Appl. No.: 10/611,507

Amdt Dated: February 11, 2005

Reply to Office Action of: November 16, 2004

REMARKS/ARGUMENTS

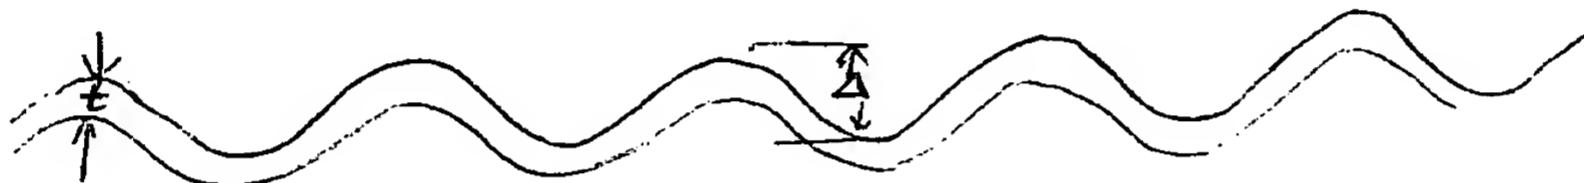
The Office Action states "With respect to claims 10 & 15, Heifinstine discusses an electrolyte sheet with the variations of thickness of at least 0.5% of the sheet thickness." However, this is not correct. The reference discloses "strain tolerance" of 0.5%, not the thickness variation of the sheet, as claimed by the Applicants (see, for example Paragraph [0008] of the reference).

More specifically, strain tolerance means that the sheet can be stretched by 0.5% without breakage. Fig 1a of the cited reference illustrates an exemplary electrolyte sheet. It is illustrated, greatly exaggerated, below.

This sheet has a thickness t and has a corrugated pattern that forms hills and valleys. The Heifinstine reference does not disclose that thickness t is variable. The corrugated sheet can be stretched by 0.5%, by making the corrugated pattern shallower, without the change in sheet thickness t . This is illustrated below.

Therefore, because the cited reference does not disclose the feature of "thickness variation of at least 2 micrometers", claims 10-12 and 15-16 are not obvious over this reference.
